# **Initial burst pressure requirement for the hydrogen storage containers**

**Transmitted by Japan**

3<sup>rd</sup> Meeting of the informal working group on GTR No.13 (Phase 2)  
26-28 June 2018 @ Seoul, Korea

Figure x Relationship between the initial BP and end-of-life BP (Estimation)

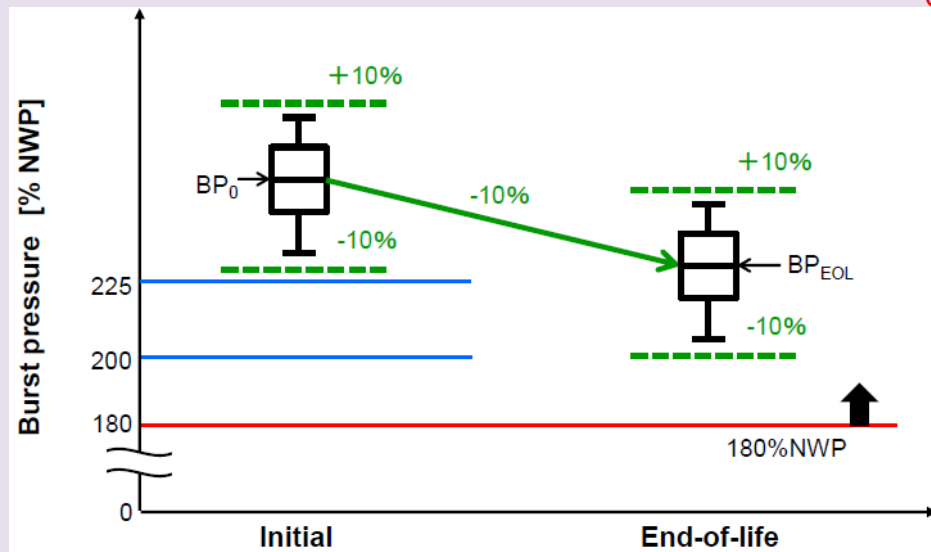
Validate the minimum initial burst pressure with the variation within  $BP_0 \pm 10\%$  to secure the end-of-life burst pressure 180% NWP and to be within  $-20\%$  of  $BP_0$ . See the estimation of figure x.

In the subsequent discussions of the phase 2, it has been verified that the minimum initial burst pressure shall be changed from 225% NWP to 200% NWP limited to carbon fiber containers ,based on the verification data provided from Japan using the actual containers.

Figure xx The results from the verification test

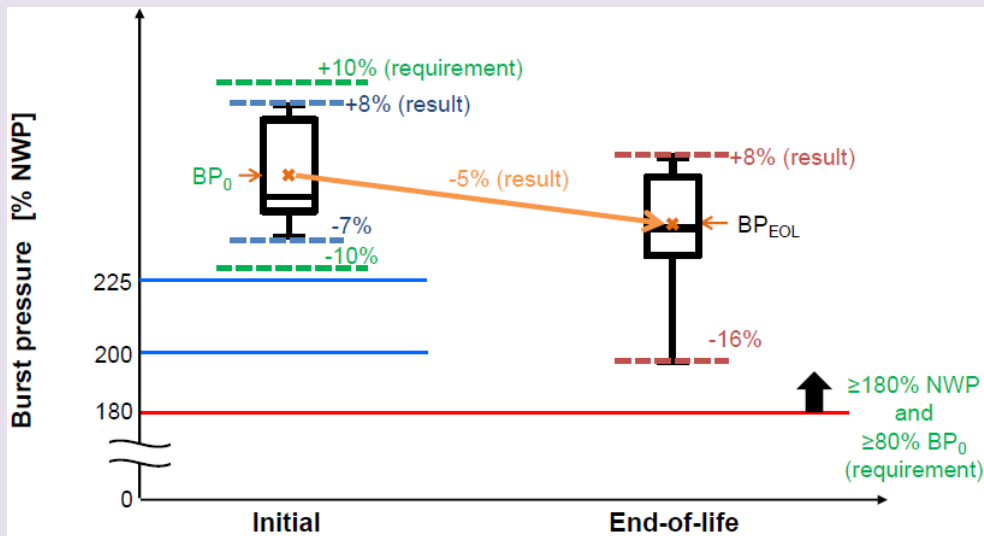
From figure xx, found out the variation of initial burst pressure of  $BP_0 \leq \pm 10\%$ , and the margin of end-of-life burst pressure to the requirements taking into account the variation and the degradation ratio. As the results like figure xxx, it has been validated that the minimum initial burst pressure of 200% NWP ( $BP_0 \geq 220\%$  NWP), the end-of-life burst pressure of 180% NWP and to be within -20% of  $BP_0$  shall be specified.

# The results of the verification test (one of 2 suppliers)

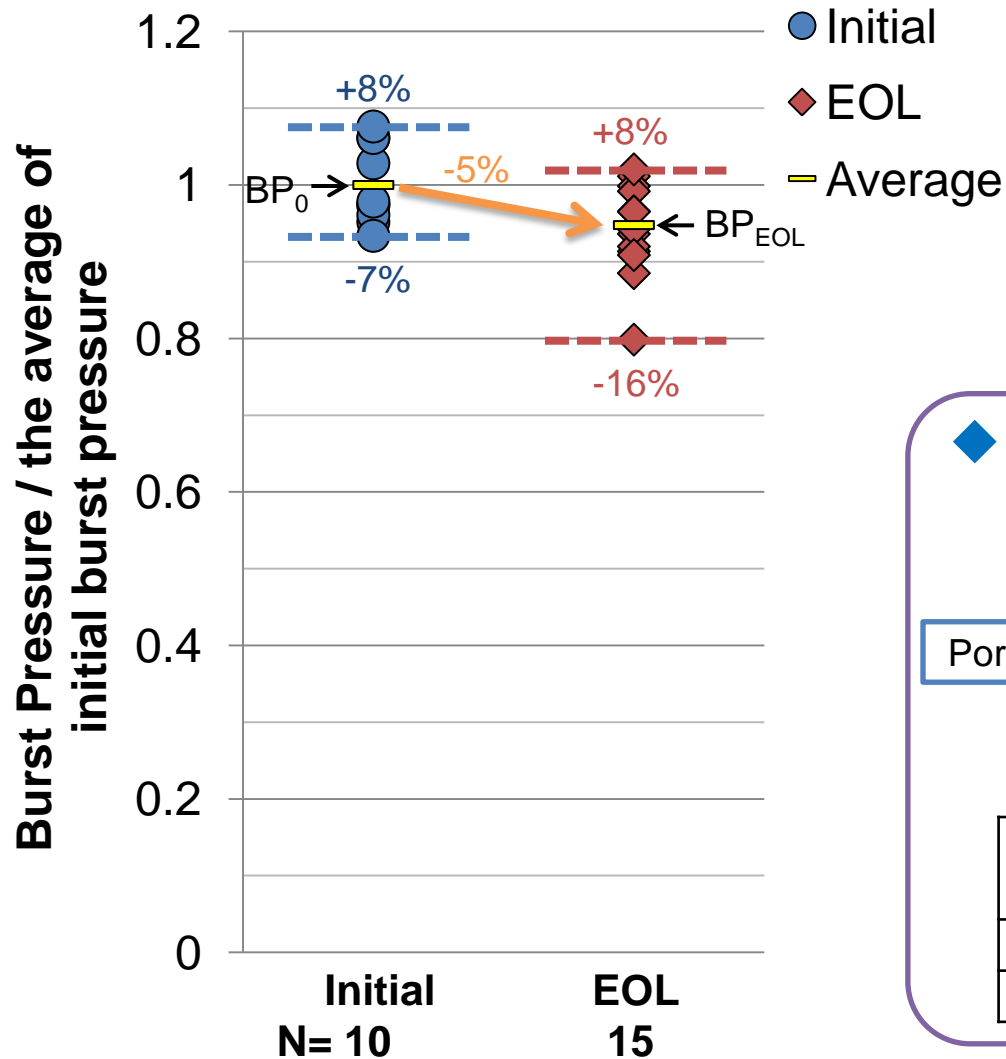
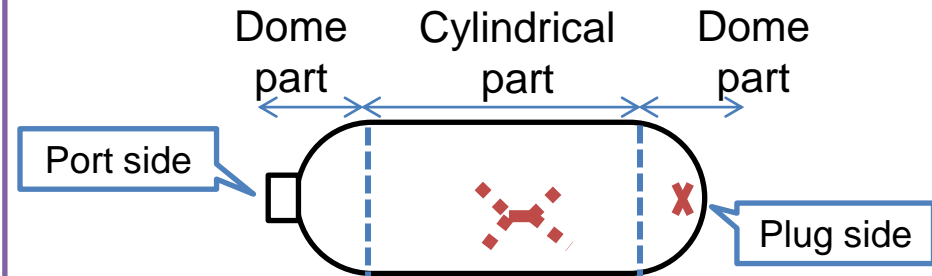
- The average of burst pressure : approx.5% decrease from initial to EOL
- The variation of burst pressure : expanded downward from approx.7% to 16%
- The starting point of rupture in EOL : half for cylindrical and half for dome

# The investigation of the burst pressure degradation

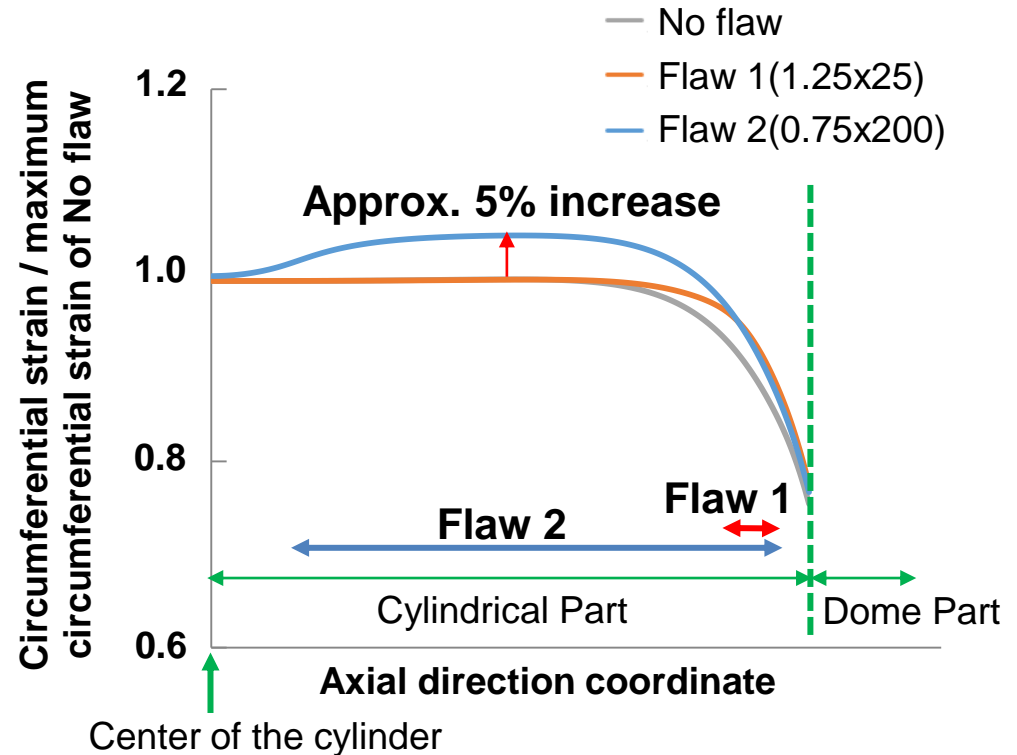
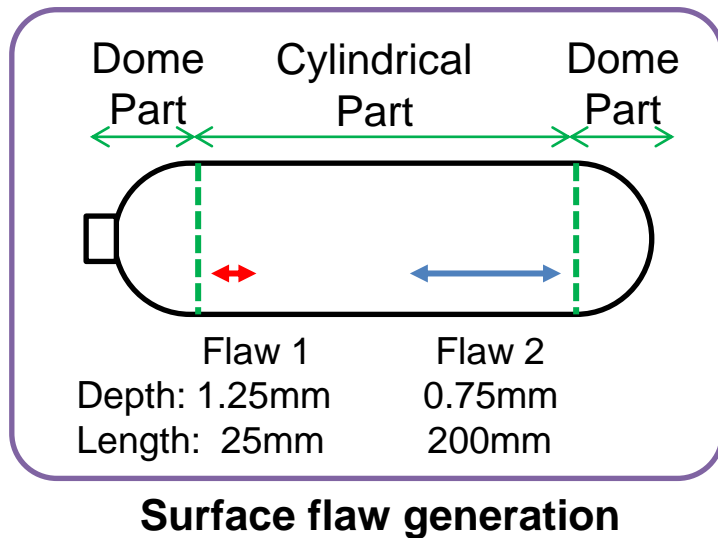
- In the case of the rupture from **the cylindrical part**
  - The influence investigation of the surface flaw by finite element analysis

- The circumferential strain of CFRP in cylindrical part increased approx.5% due to surface flaw.
  - **The surface flaw is considered to be the factor of the decrease in burst pressure as the starting point of rupture in cylindrical part.**

# The investigation of the burst pressure degradation

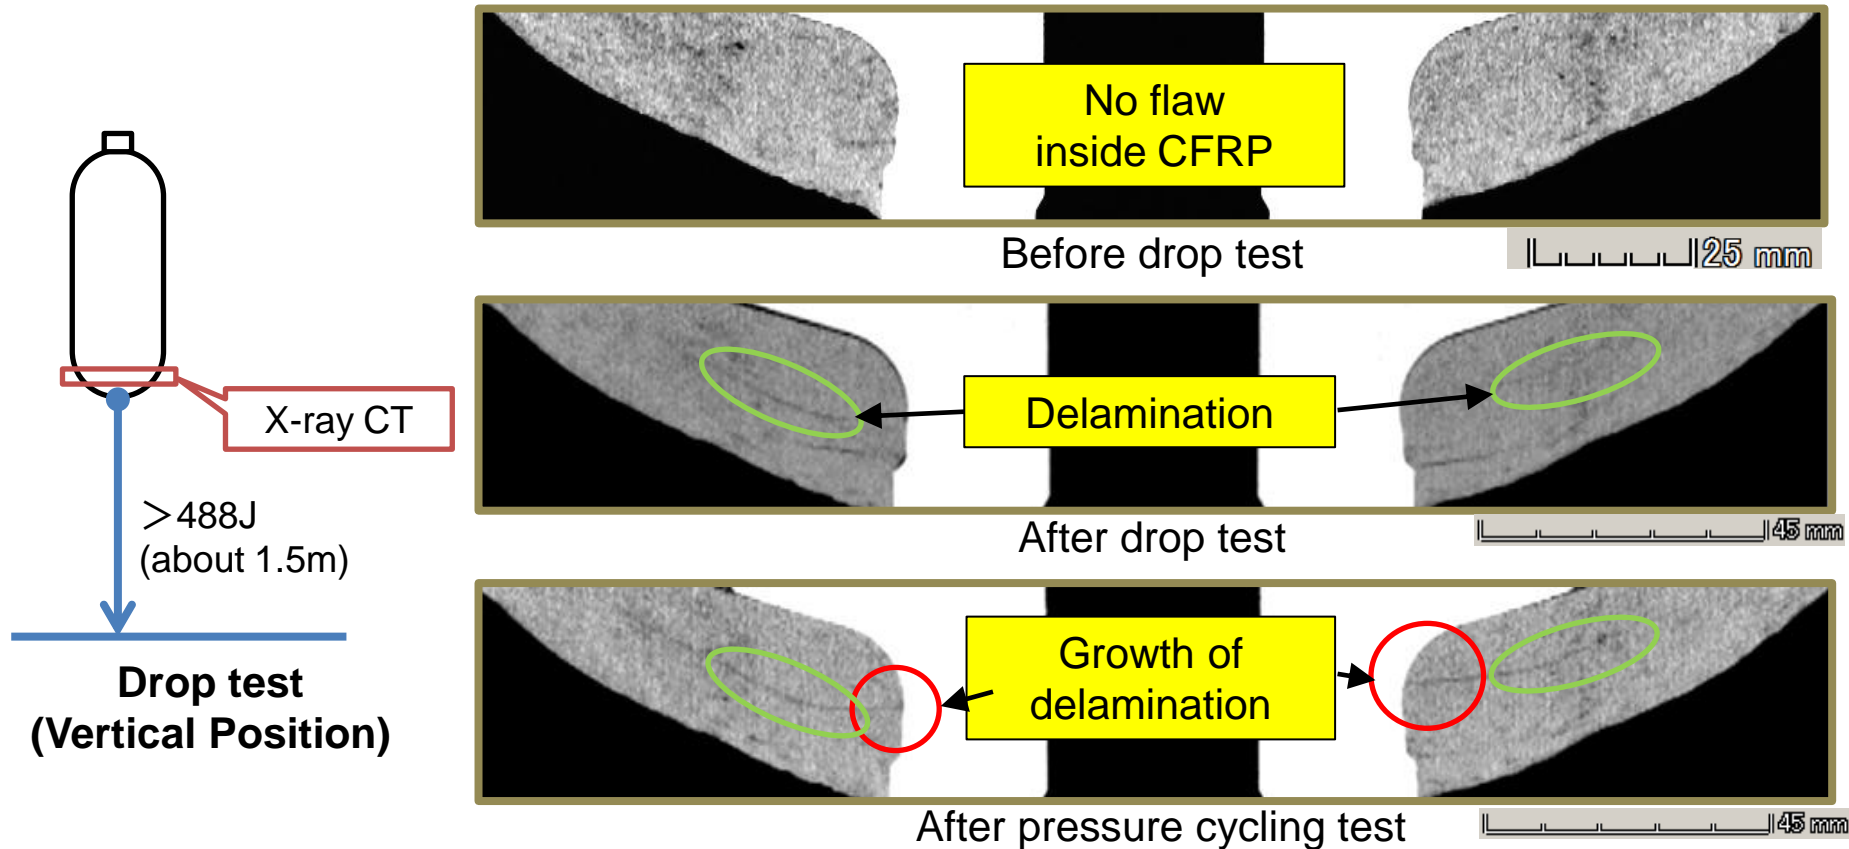
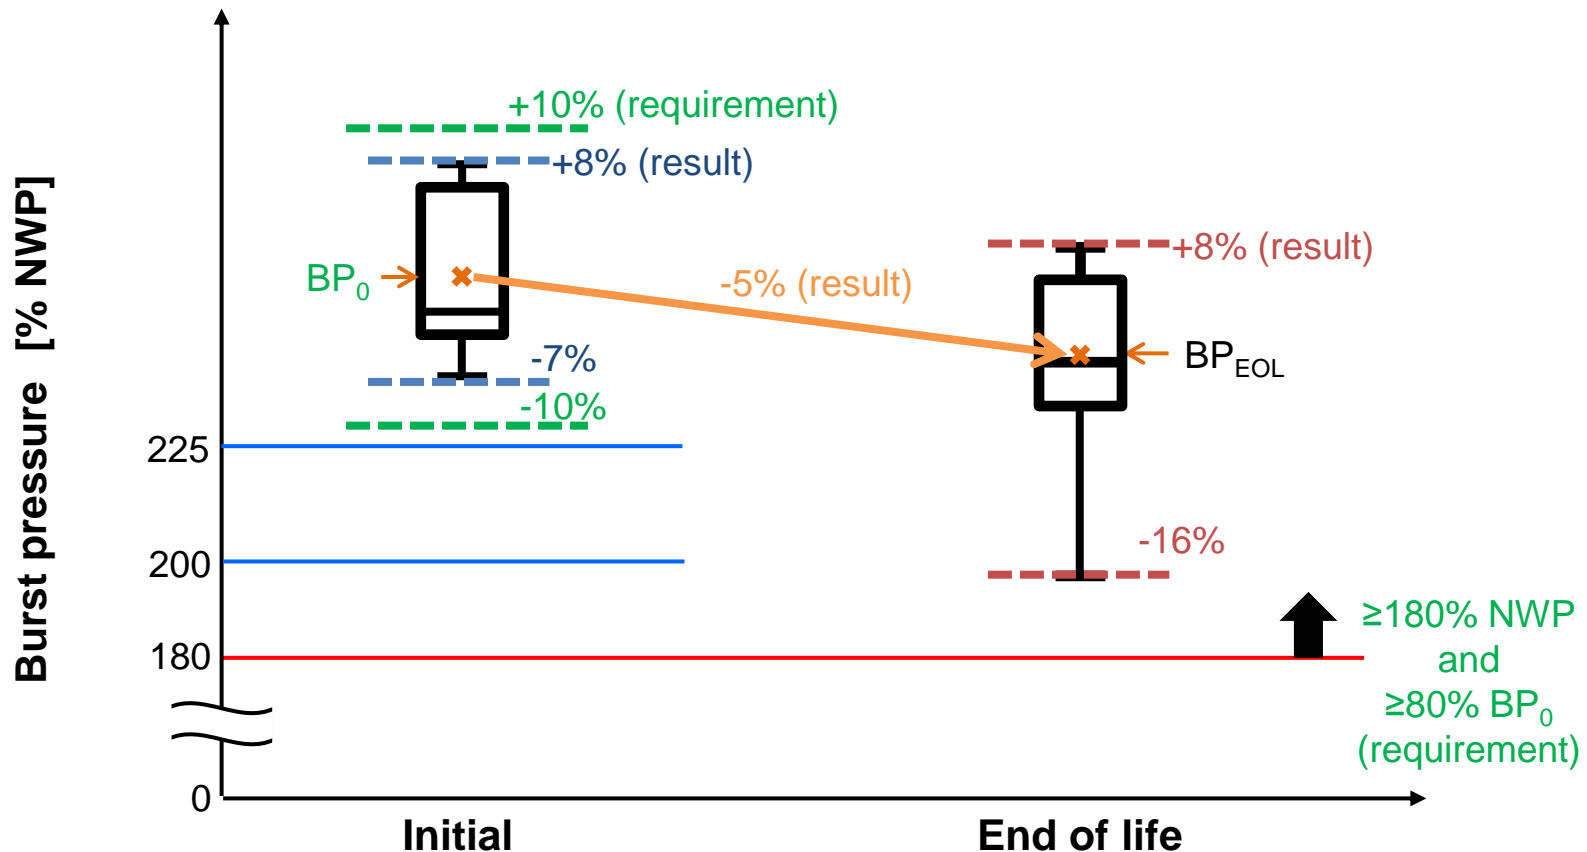
No flaw (initial) ➤ Delamination (after drop) ➤ Growth of delamination (after cycling)

- **The delamination inside CFRP by the drop test is considered to be the factor of the decrease in burst pressure as the starting point of rupture in dome part.**

# The possibility of the design qualification test modification

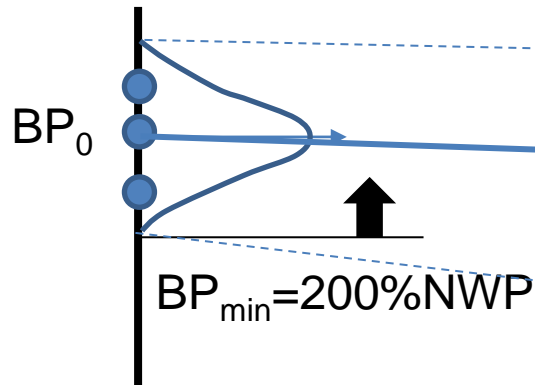
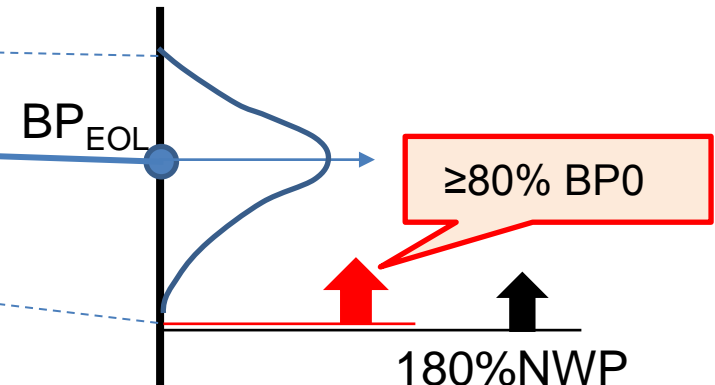
- Change from 225% NWP to 200% NWP as the minimum initial burst pressure  $BP_{min}$
- No change of the design qualification test without the requirement of  $BP_{min}$  (above)

**Three (3) new containers** randomly selected from the design qualification batch of at least 10 containers, are hydraulically pressurized until burst. All containers tested shall have a burst pressure within  $\pm 10$  per cent of  $BP_0$  and greater than or equal to a minimum  $BP_{min}$  of **200 ~~225~~ per cent NWP**.
